**NOTICE OF ADDENDUM
ADDENDUM NO. 2**

**CONTRACT NO. 7939
MADISON MUNICIPAL BUILDING - RENOVATION**

This addendum is issued to modify, explain or correct the original Drawings, Specifications, or Contract Documents and is hereby made a part of the contract documents.

1 TYPICAL PARAPET WALL AT ADDITION
A353 3" = 1'-0"

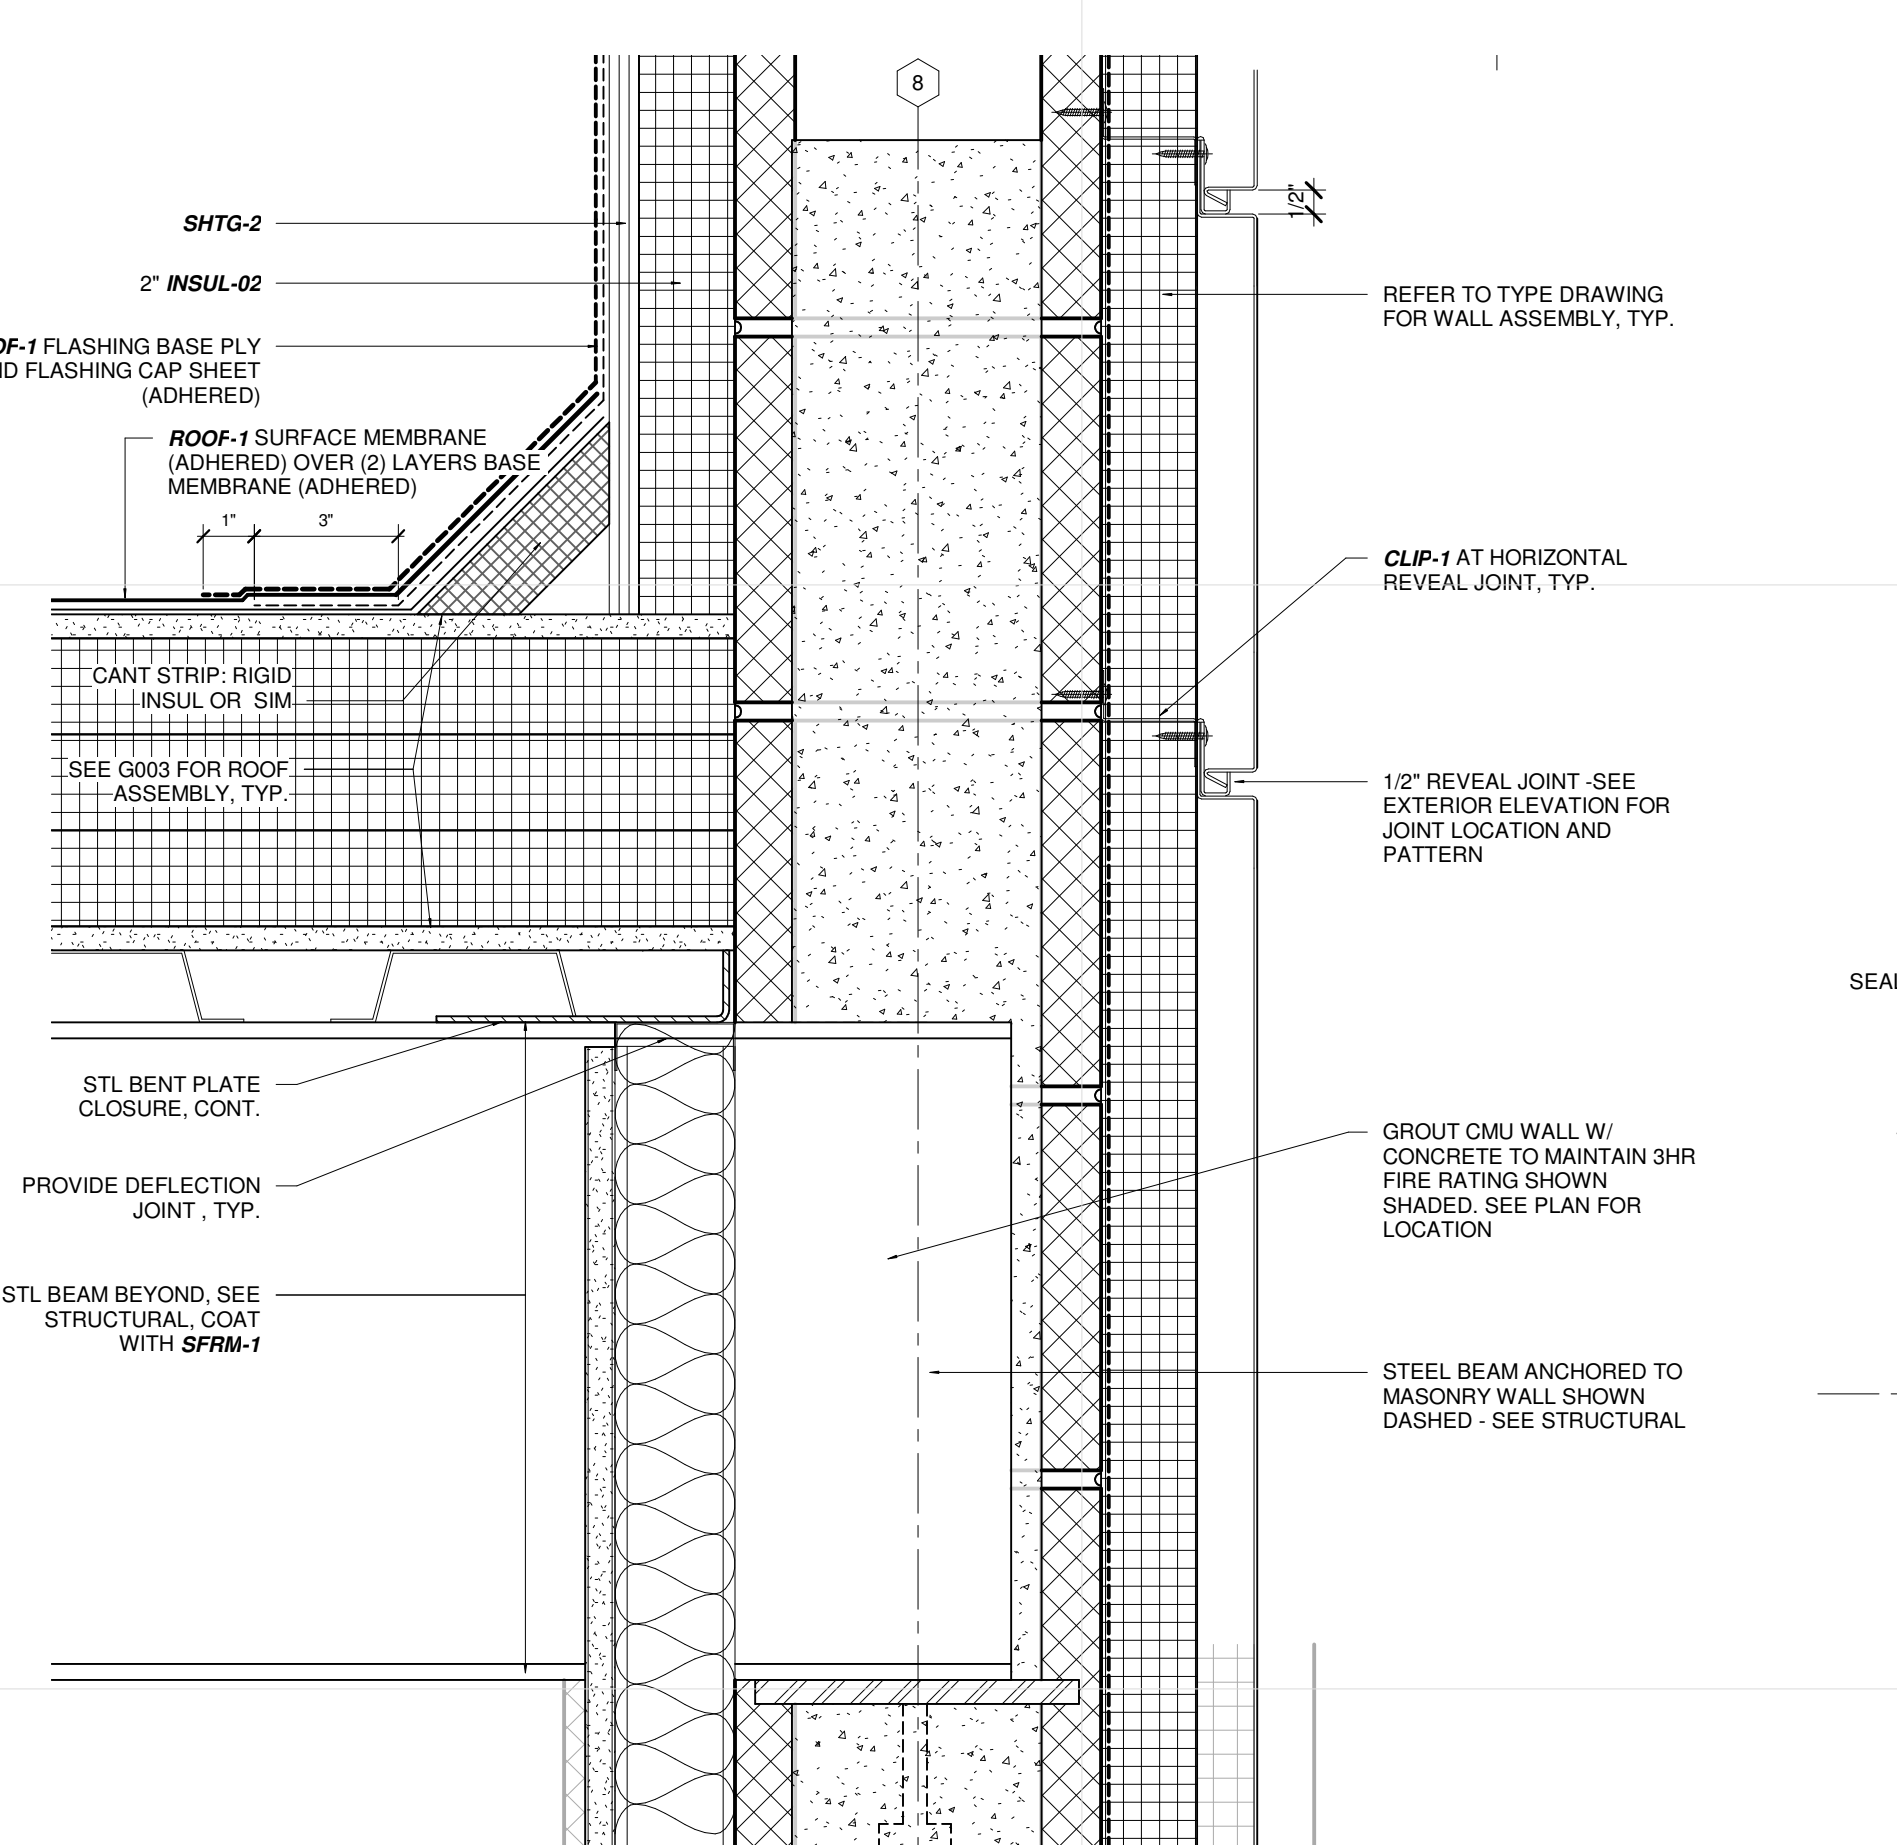
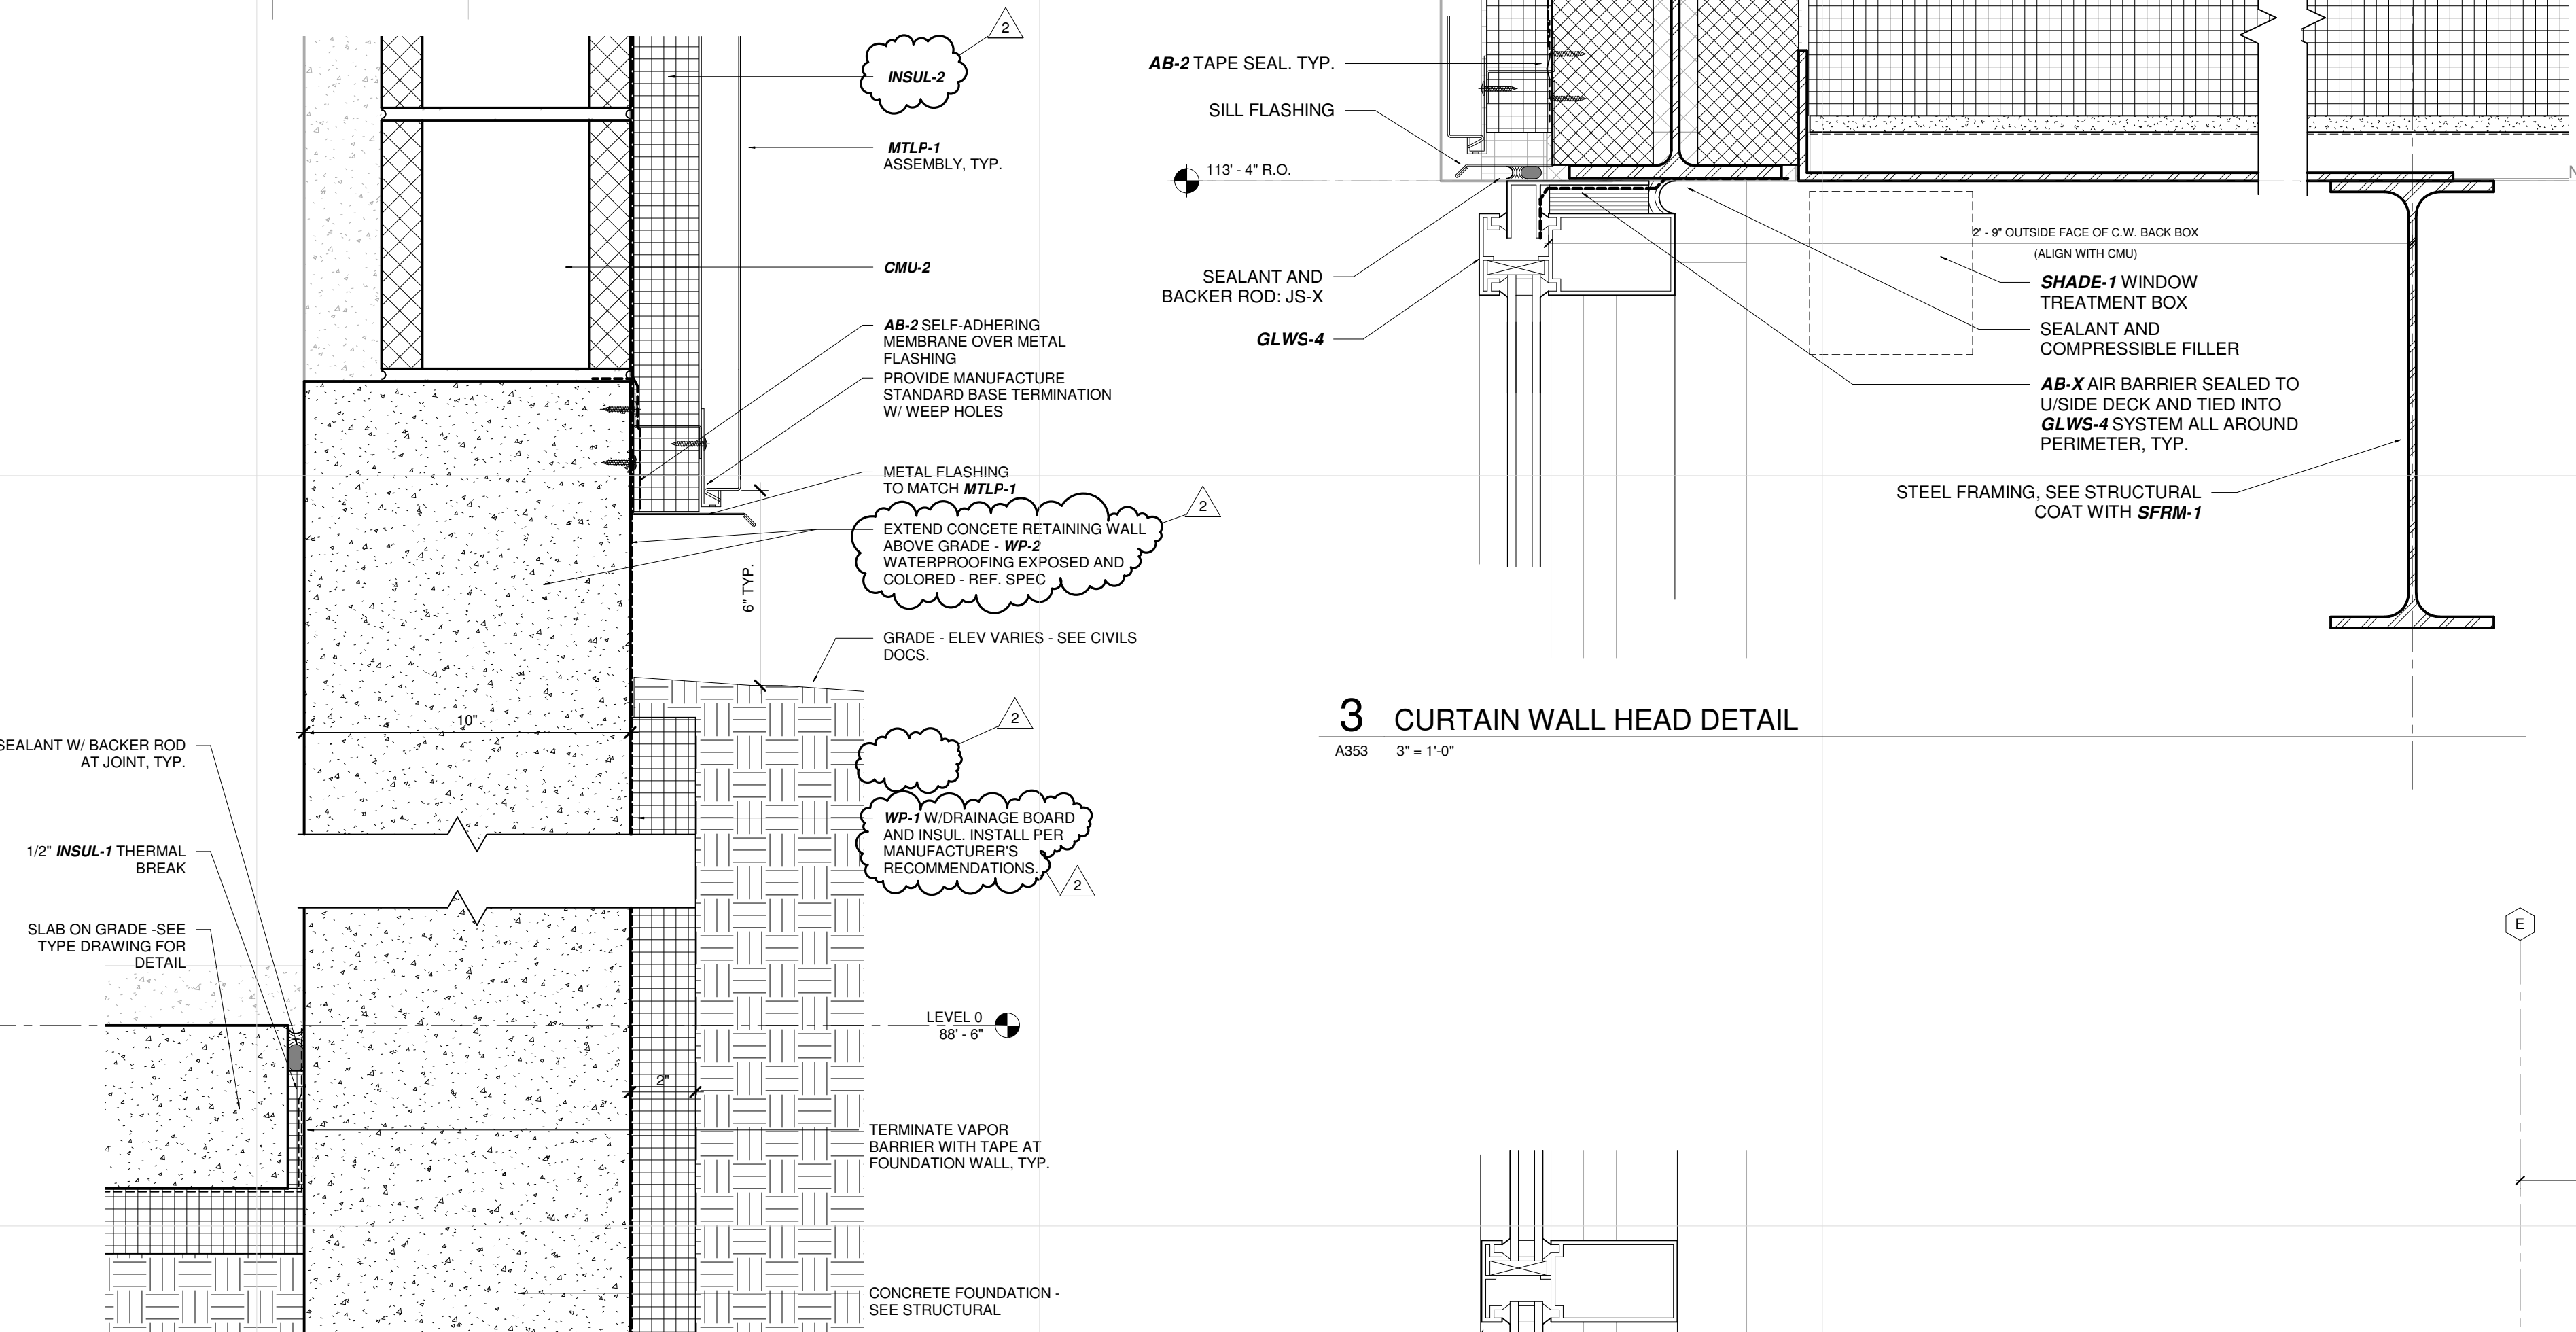
1. Detail 1/A192 Revised to center vestibule on exterior doors.
2. Details 7 and 8/A301. Revised details to clarify waterproofing notes.
3. Details 5,7 and 9/A353. Revised details to clarify waterproofing notes.
